**CITY OF ROCKVILLE HISTORIC DISTRICT COMMISSION
STAFF REPORT
for
March 20, 2008
MEETING NO. 03-08**

APPLICATION:	HDC2008-00416
ADDRESS:	12 Wall Street
ACCEPTED:	March 14, 2008
45-DAY LIMIT:	April 11, 2008
OWNERS:	Raymond J. Whalen.
REQUEST:	Demolish existing 200' fence and replace with 250' of new fence. Replace rusted 120' of fence with new fence
STAFF:	Jeffrey Winstel

VIEWS OF AFFECTED RESOURCE:

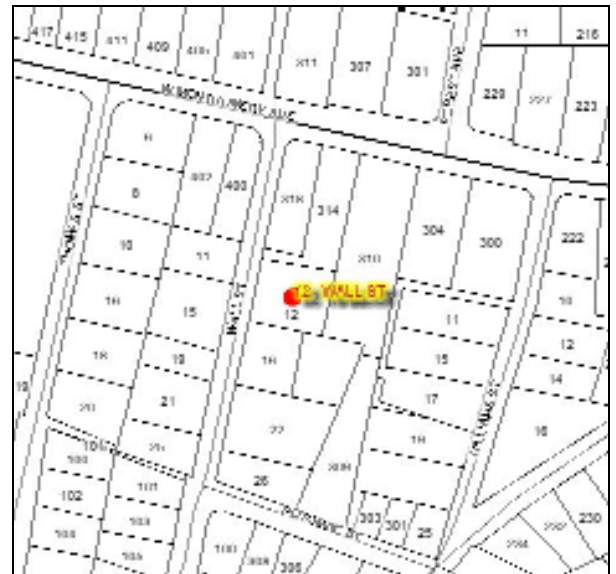
The proposed new fence will not have an adverse impact on the character of the England House's environmental setting. The removal of the non-compatible rusting chain link fence will improve the environmental setting and the proposed new fencing will be compatible with the character of the West Montgomery Avenue Historic District.

The proposed removal of the chain link fencing and installation of new metal picket fencing will result in fencing that is more compatible with the historic character of the district.
